RAYMORE PLANNING AND ZONING COMMISSION AGENDA

To: Planning and Zoning Commission
From: Dylan M. Eppert, City Planner
Date: February 7, 2023
Re: Case #23001 - Willowind Square, Lot 2 - Site Plan

Requested Action: Site plan approval for Willowind Square, Lot 2

SITE PLAN

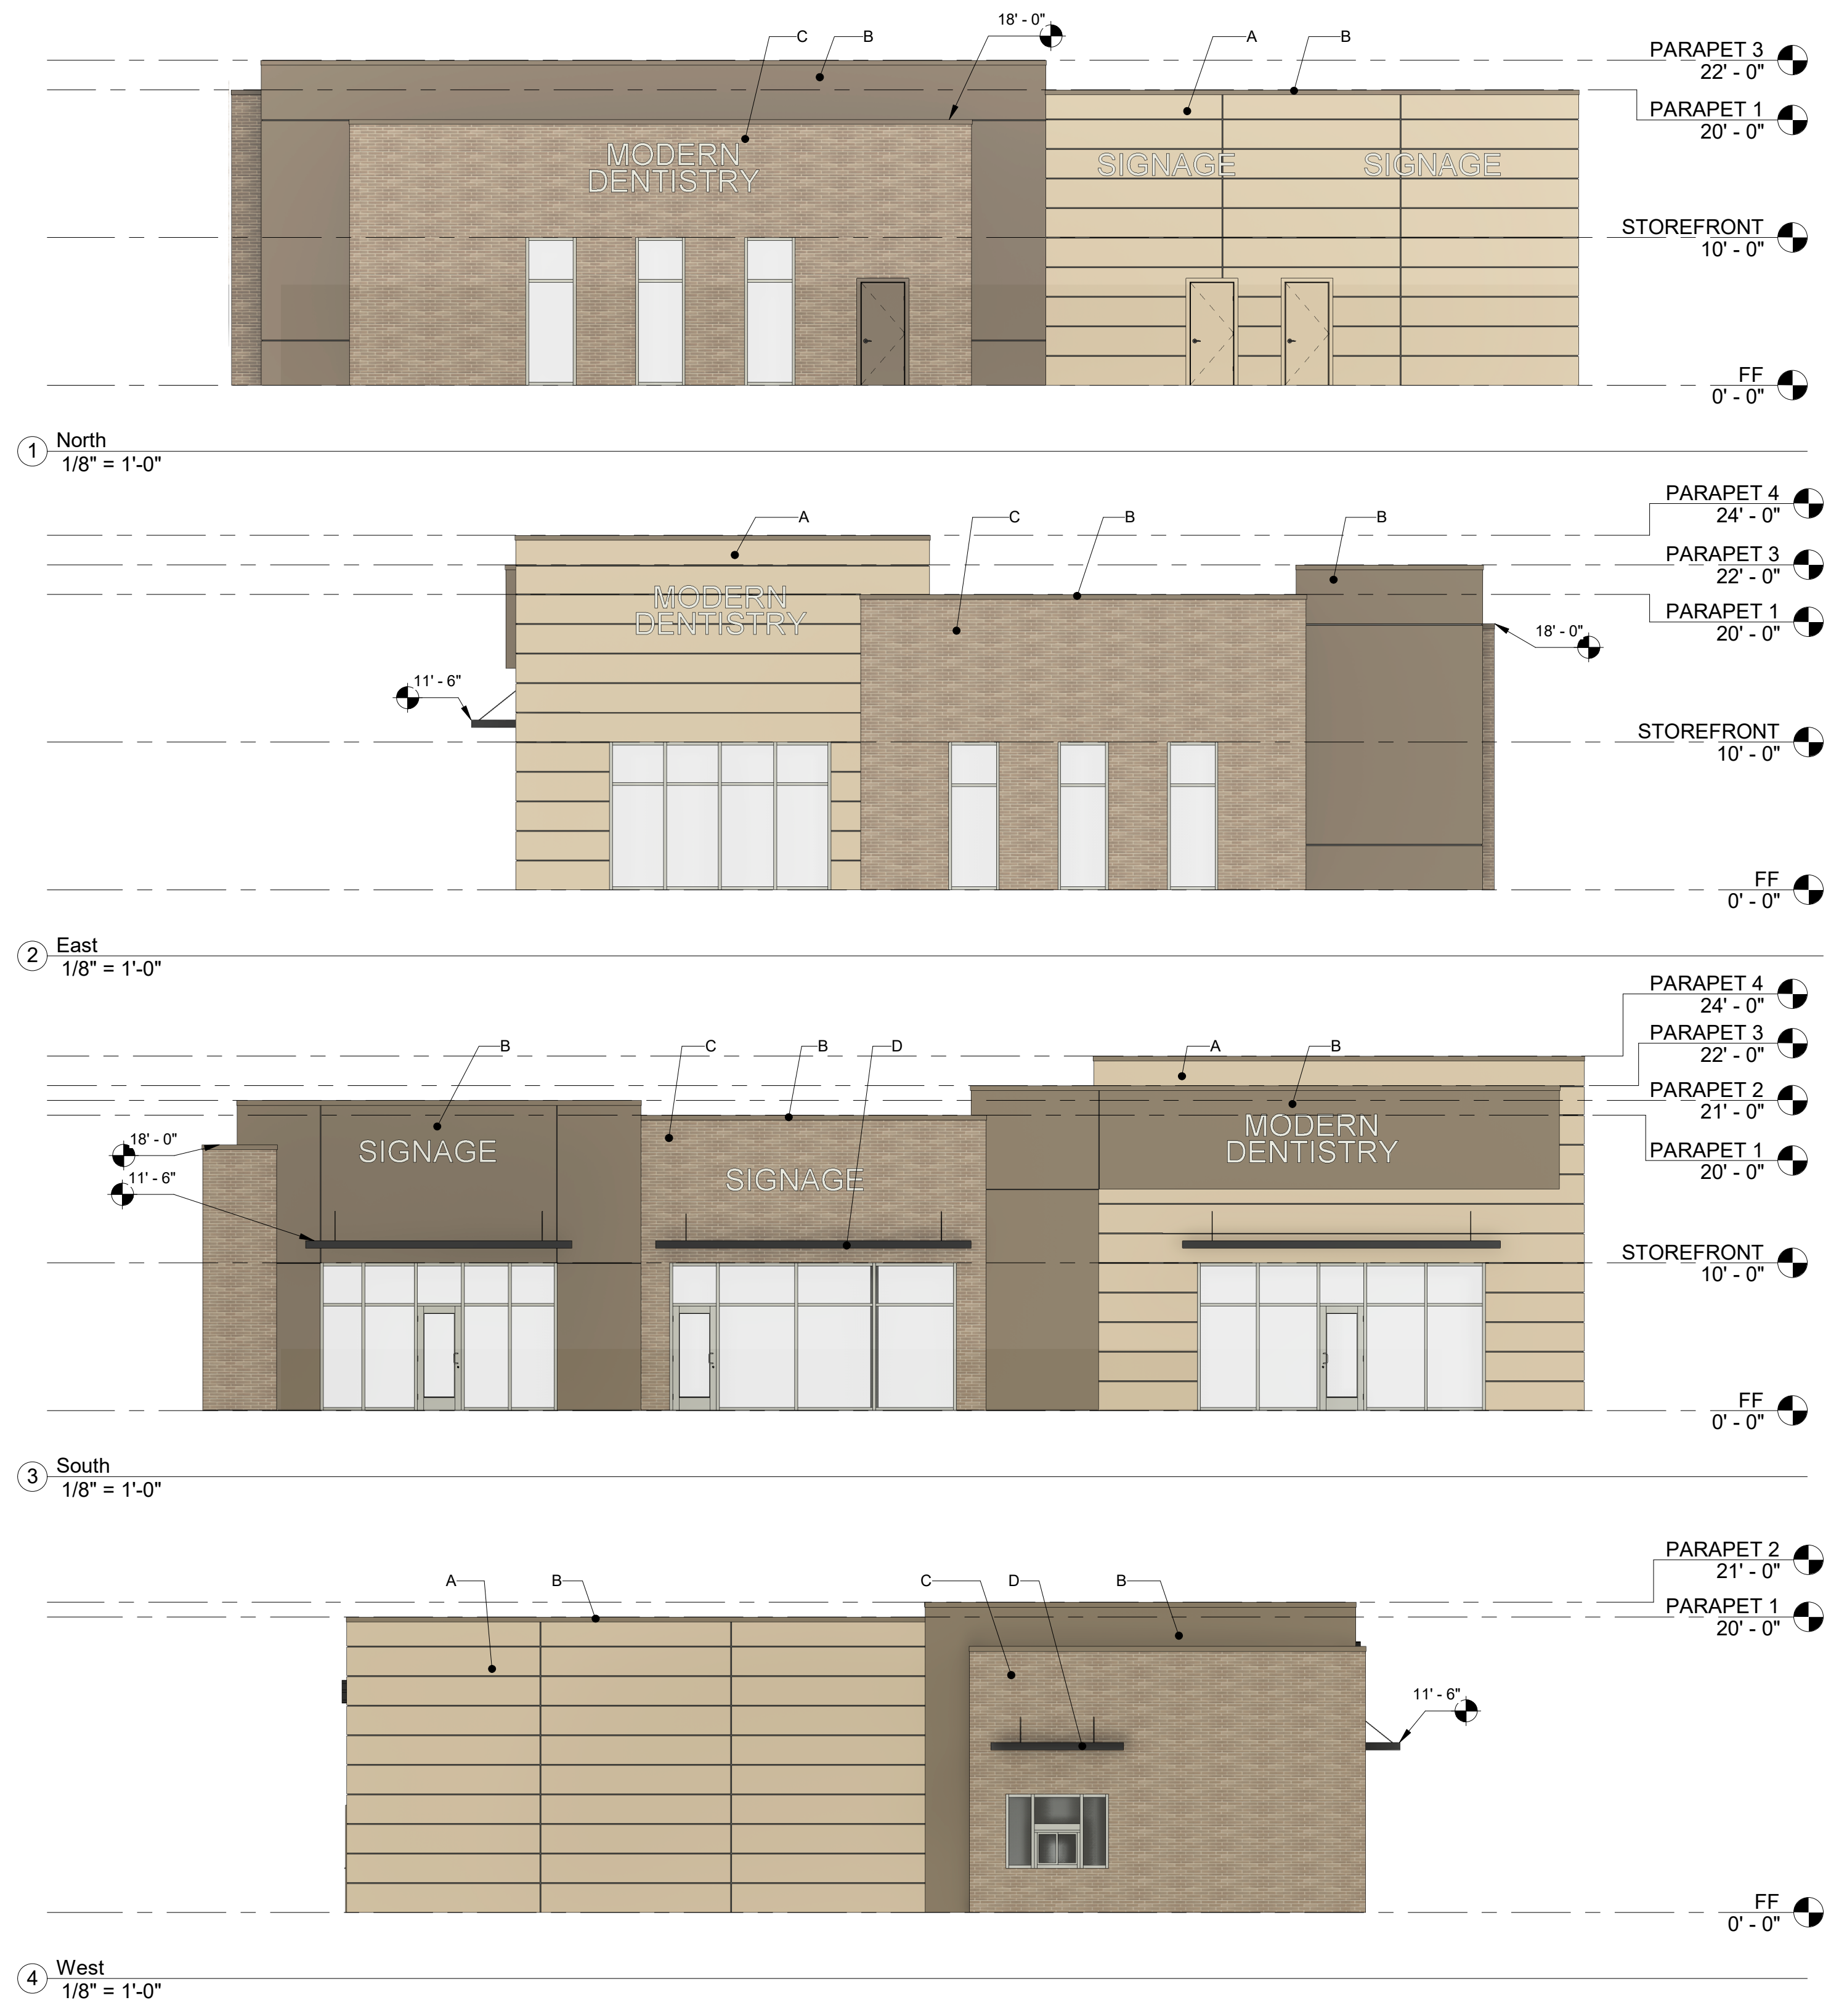
The proposed site plan is in compliance with the parking standards for the City of Raymore by providing the 31 parking spaces, where only 27 spaces are required. The site plan also provides the required number of accessible parking spaces. A total of 2 accessible spaces are required and 2 spaces are provided.

- 6. **Pedestrian Access:** Pedestrian Access to the building has been provided. A sidewalk will be required to be constructed from the existing sidewalk along 58 Hwy towards the entrance of the multi-tenant building as well as a striped pedestrian crossing.
- 7. **Signage:** Sign permits are required prior to installation of any sign. If a monument sign is proposed in the future the monument sign must be in compliance with the UDC including the landscaping requirement.
- 8. **Fire District Review:** The site plan was reviewed by the South Metropolitan Fire Protection District. A truck turning movement plan was submitted as required.

The site plan does provide for safe, efficient and convenient movement of pedestrians. Sidewalks are provided to allow pedestrians access to the site from 58 Hwy.

The placement of the building in the middle of the lot does allow for efficient use of the land and minimizes potential adverse impacts on existing and planned municipal infrastructure and services.

The staff recommends the Planning and Zoning Commission accept the staff proposed findings of fact and approve Case #23001 Willowind Square Lot 2 - Site Plan subject to the following eleven (11) conditions:

1 ELECTRICAL SITE PHOTOMETRIC PLAN
 E-1 SCALE: NTS NORTH

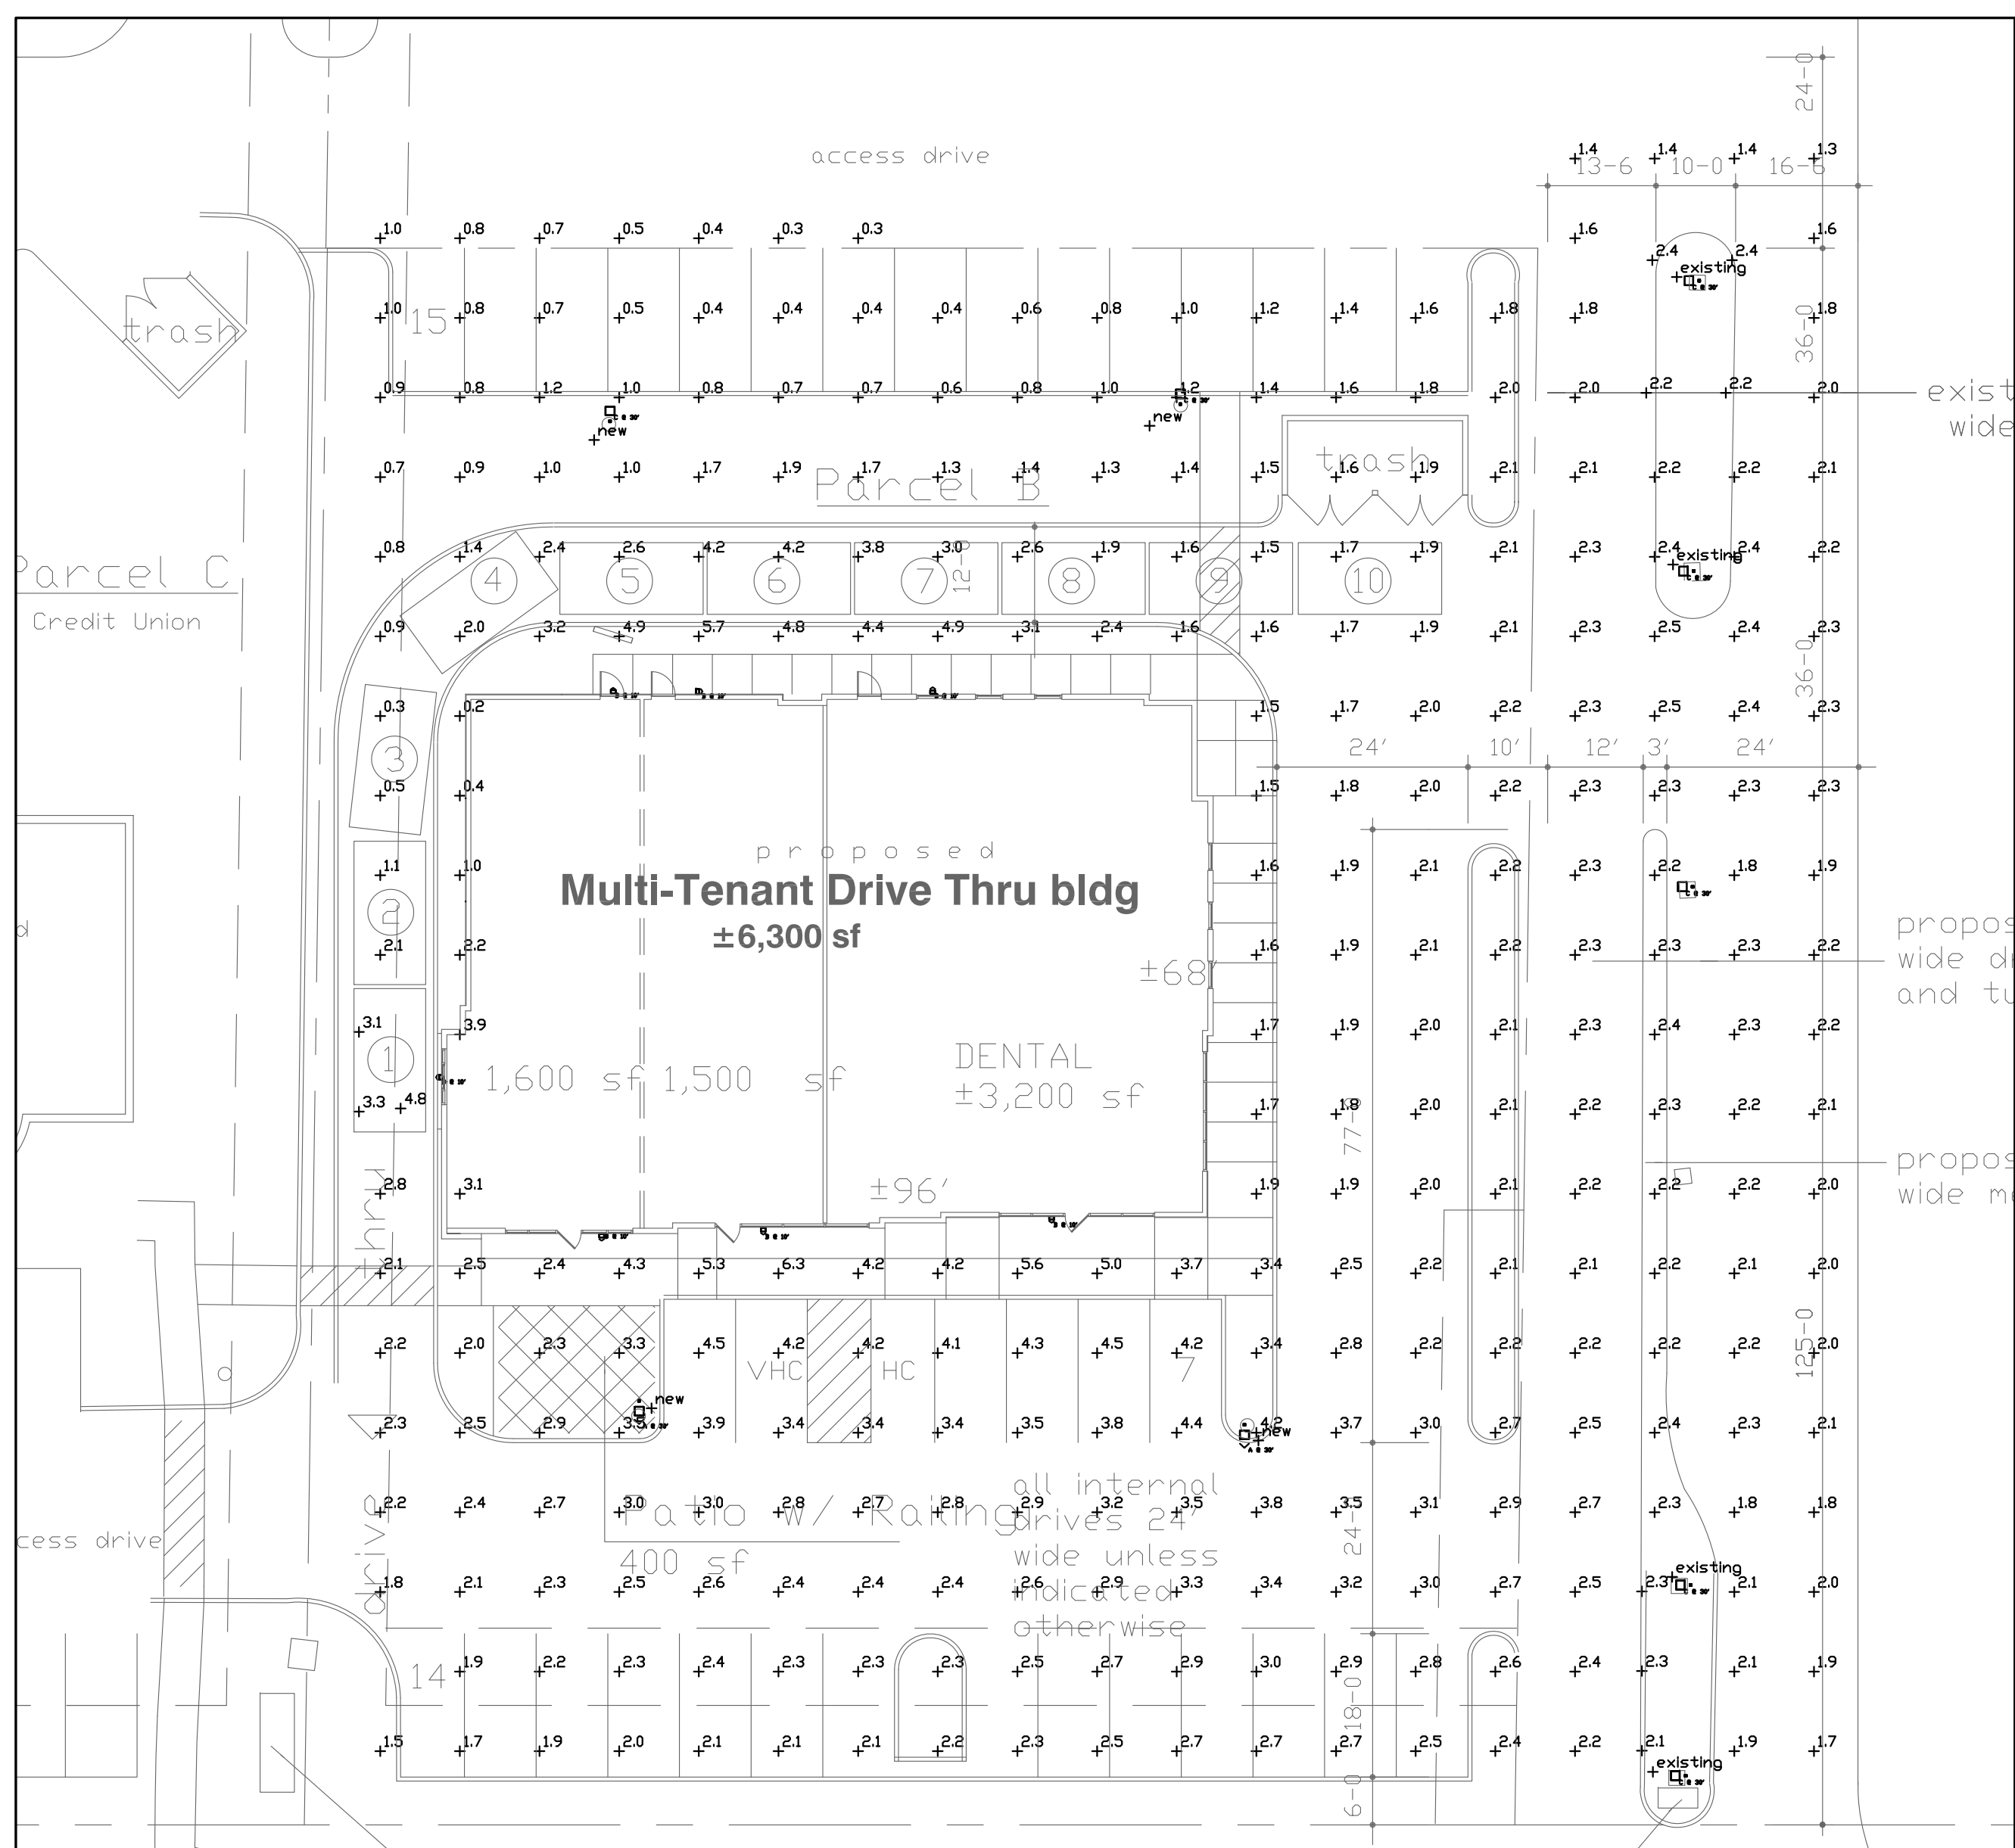
- 10. **Site Lighting:** The proposed site lighting plan is in compliance with the outdoor lighting performance standards of the City.
- 11. **Trash Enclosure:** The exterior of the trash enclosure will be constructed of CMU or similar materials as the main building. The enclosure is located on the northeast corner of the site. The enclosure gates will be made out of Metal or similar material.

MASTER PLANTING PLAN

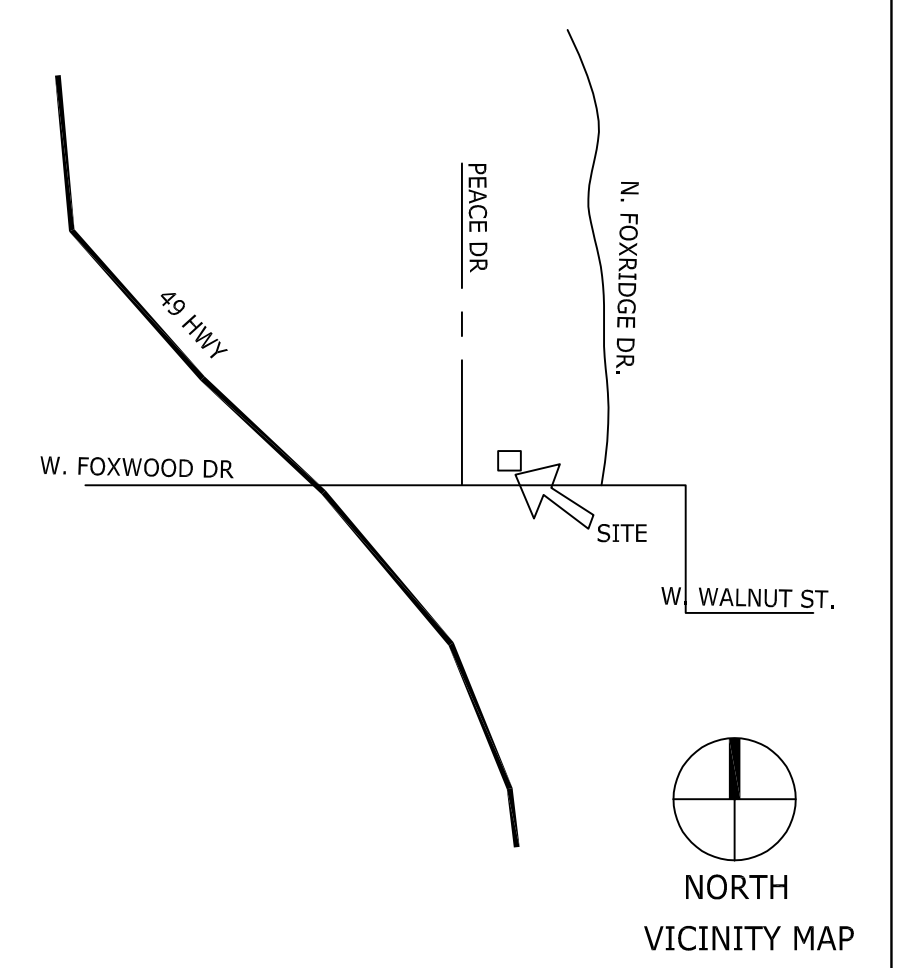
3 ½ feet shall be screened. The landscape plan does not show any screening around the equipment. This requirement will be monitored when the equipment is installed to determine the applicability of the requirement.

Various (5-6) mature trees exist on the site, which were planted in such a way that to serve as parking lot landscaping for the entire Willowind Center. They do not, however, serve the proposed layout of the site, and thus will be removed where needed. New parking lot landscaping has been provided to offset the loss of these trees.
